BELL SYSTEM PRACTICES

ADDENDUM C55.162

**TELEPHONE SET
595 TYPE
(DISTANT TALKING SET)**

1.02 All sets manufactured after November 1954 are wired in accordance with the drawings in this provisional addendum.

**592 A/B-3
Telephone Set Connections**

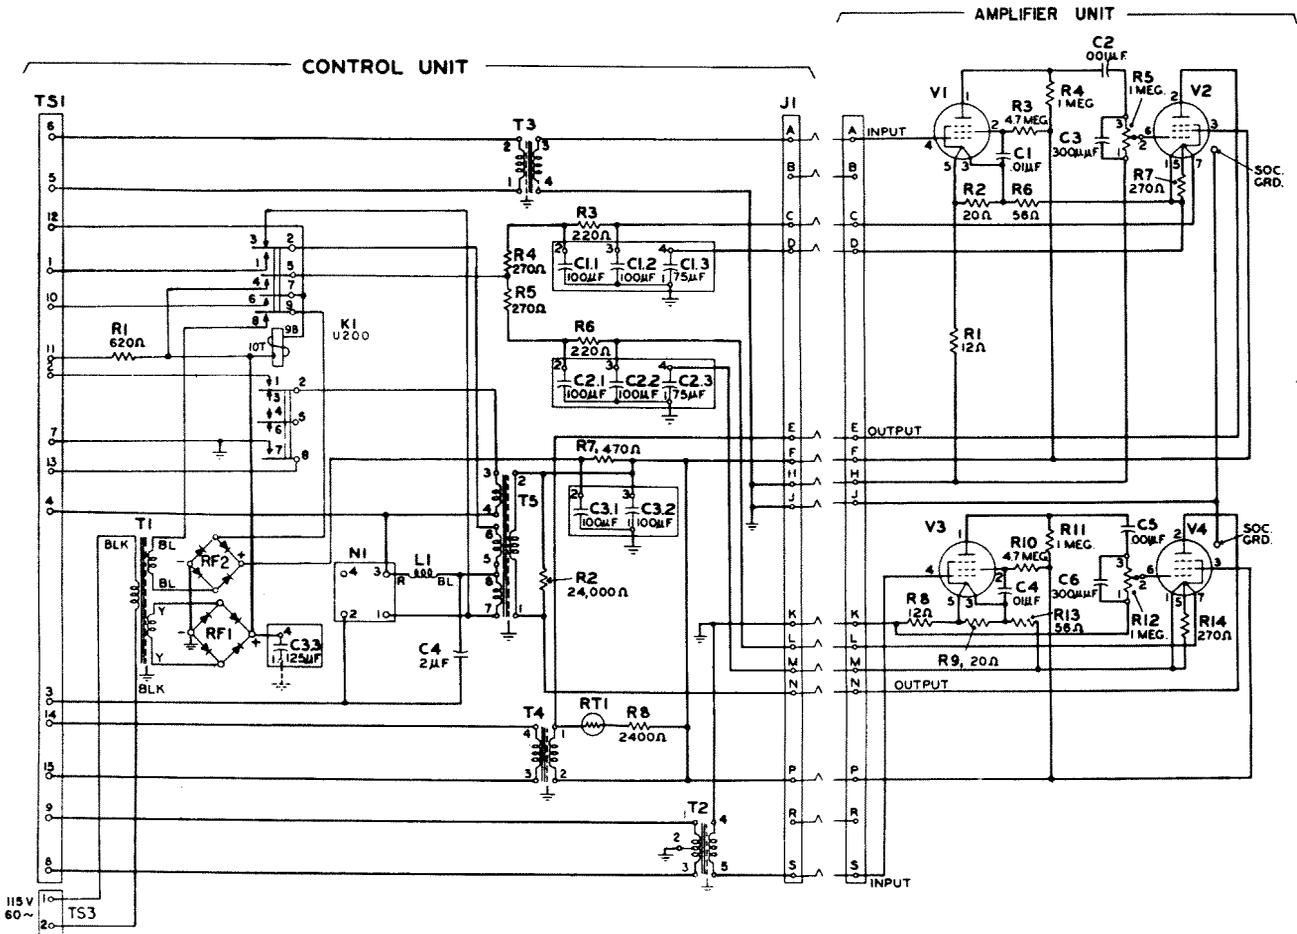
NOTE 1: Contact Sequence

Removing Handset

1. cb closes before de
2. fg opens

Restoring Handset

1. fg closes
2. de opens before cb

NOTE 2: Manual Service

1. Replace dial with 95B-3 apparatus blank.
2. Move green lead from "F" to "RR" on the-network.
